Commonwealth Edison Company
Dresden Generating Station
6500 North Dresden Road
Morris, IL 60450
Tel 815-942-2920

Dresden Nuclear Power Station, Units 2 and 3
Facility Operating License Nos. DPR-19, and DPR-25
NRC Docket Nos. 50-237 and 50-249

Subject: Response to Request for Additional Information Regarding Unresolved Safety Issue (USI) A-46

ATTACHMENT A
Response to Request for Additional Information for Dresden Nuclear Power Station
Unresolved Safety Issue (USI) A-46

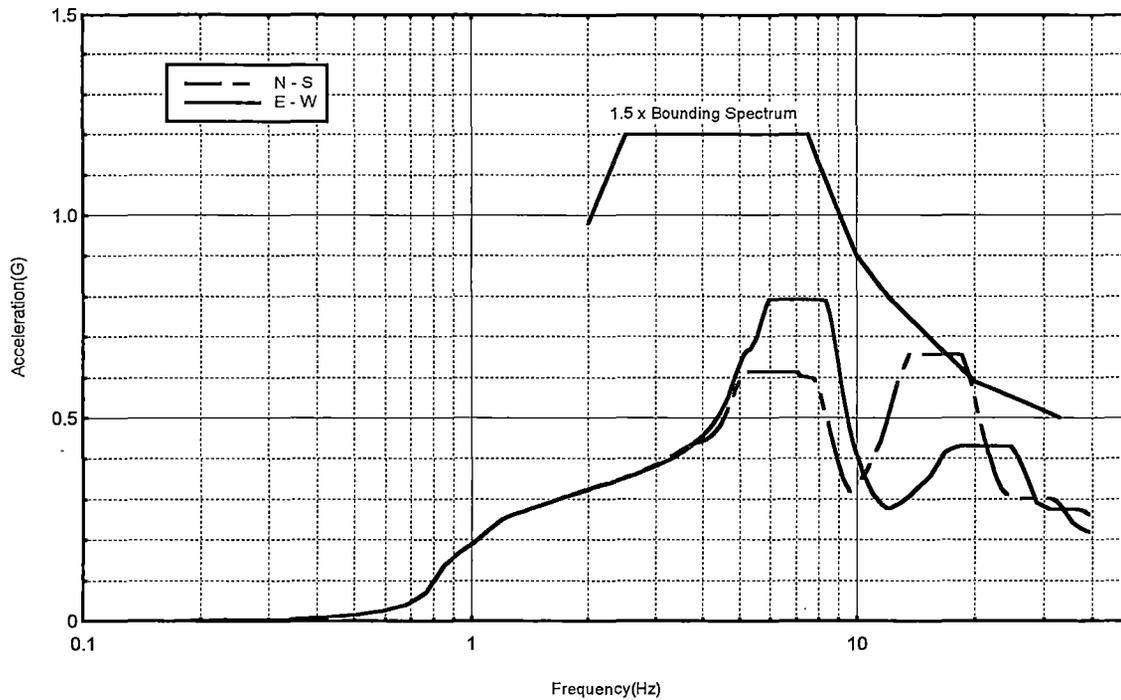
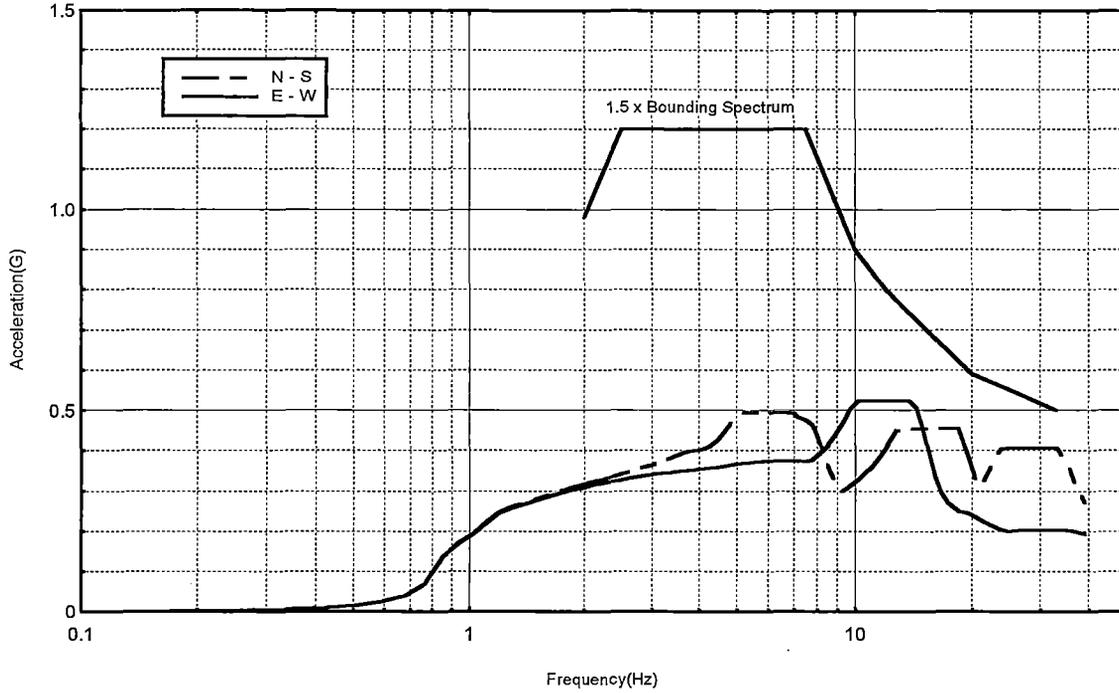
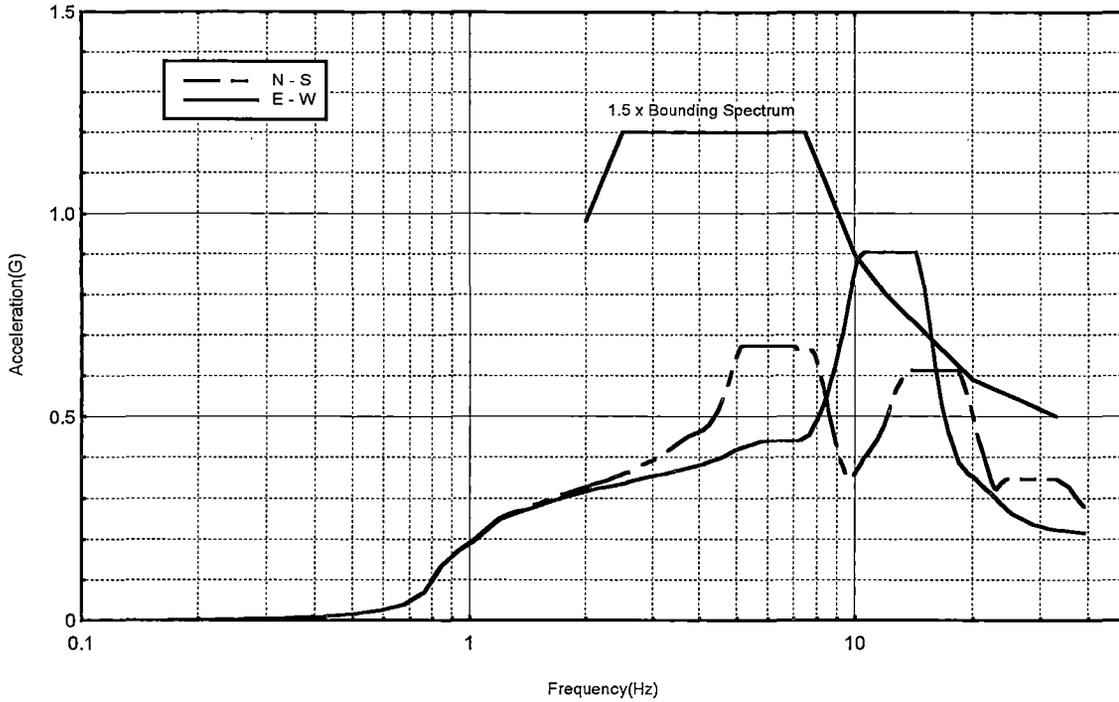
In response to the staff's question on the appropriate use of Method A of Table 4.1 of generic implementation procedure number two (GIP-2), you make reference to the Seismic Qualification Utility Group's (SQUG) letter of January 1998 (Reference 3). The staff is aware of the bases provided in the reference. More recently, SQUG has acknowledged in its letter of August 18, 1998, and the staff has agreed to in its letter to SQUG of September 21, 1998: "Any plant-specific implementation concerns should be addressed in the plant-specific evaluations." The restriction on the use of Method A comes from the discussion of "Advantage and Limitations" in Section 4.2.3 of GIP-2, where it is noted that "Seismic Capability Engineers should be alert for unusual, plant specific situations which could cause the amplification factor to be greater than that of typical nuclear plant structures." A review of some of the in-structure response spectra (IRS) provided in Appendix B (Reference 1) shows that at several elevations, the IRS in the Reactor Building and Turbine Building have double peaks (broadened); (1) between 4 and 8 Hz, and (2) between 12 and 20 Hz. This indicates a plant-specific situation. The staff's concern is about the seismic adequacy of equipment including their supports and anchorages (such as electrical equipment, valves, and electrical relays or contacts) located within 40 feet above the effective grade of 517 feet. In light of this discussion (1) provide justification for the use of Method A, (2) as an example, provide your justification for seismic adequacy of safe shutdown equipment list (SSEL) equipment installed on Elevation 549 feet of the turbine Building.

Figures 1 – 3 show the refined ISRS broadened by $\pm 15\%$ compared to the GIP reference spectrum (1.5 x bounding spectrum) for the Reactor and Turbine building elevations within 40 of grade for which Method A has been utilized. All of our refined ISRS are enveloped by the GIP reference spectrum with a single minor exception of the East-West ISRS of the Turbine building at elevation 549 feet. (Note that the marginal exceedance for the North-South direction of the Reactor building is acceptable by Section 4.2 of the GIP). For elevation 549 feet of the Turbine building, the broadened refined ISRS exceeds the reference spectrum between about 10-15 Hz. In Section 4.2 of the GIP, it is stated that unbroadened response

- New, more refined ISRS are developed for Dresden Nuclear Power Station for A-46 outlier resolution. The development of these new spectra is described above and the broadened spectral plots are shown in Figures 1-3. For elevations where Method A was utilized, the new spectra are enveloped by the SQUG reference spectrum with the single exception of a narrow band exceedance of about 15% for the East-West direction of elevation 549 feet of the Turbine building as shown in Figure 4. These new refined spectra still contain conservative bias that artificially increases amplifications over those that would be expected in an actual earthquake. Further, the expected differences between calculated and actual building responses do not represent a significant safety issue for resolution of USI A-46. Our bases for this are given in Attachment C.

Figure 4
Turbine Building - Elevation 549

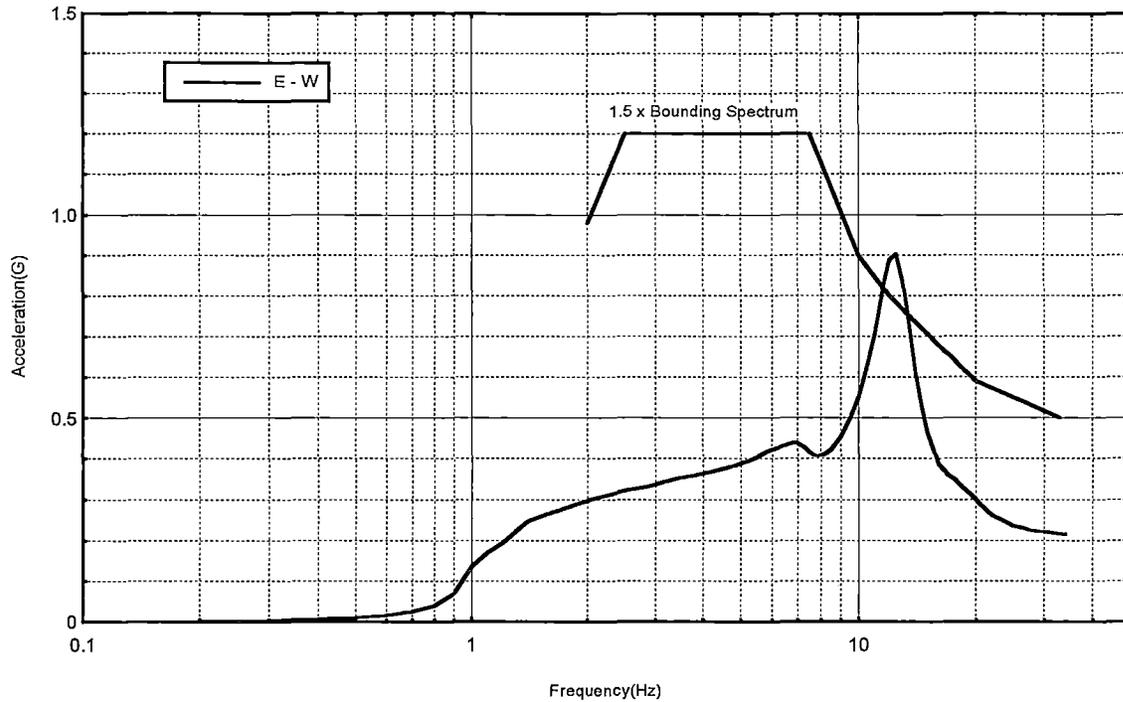
spectra may be used for purposes of this comparison. Figure 4 shows the unbroadened refined East-West ISRS of the Turbine building at elevation 549 feet. This unbroadened spectrum peaks at 12.5 Hz where the exceedance is about 15% (0.90g/0.785g) at that frequency over the reference spectrum amplitude and the width (frequency range) of the entire range of exceedance is from about 11.7 Hz to 13.3 Hz, slightly more than 10% of the frequency range of the peak frequency. For this elevation the narrow band exceedance is greater than that allowed by the GIP procedure, but only by a nominal amount. Furthermore, the ISRS at elevation 549 feet would be less than the reference spectrum had ComEd endeavored to eliminate the residual conservative bias associated with the use of a best estimate (median) model and the effect of ground motion incoherence. This is further underscored by the discussion in Attachments B and C that discuss the conservative bias in the development of ISRS. On this basis, ComEd considers this exceedance not to be safety significant and, therefore, acceptable.
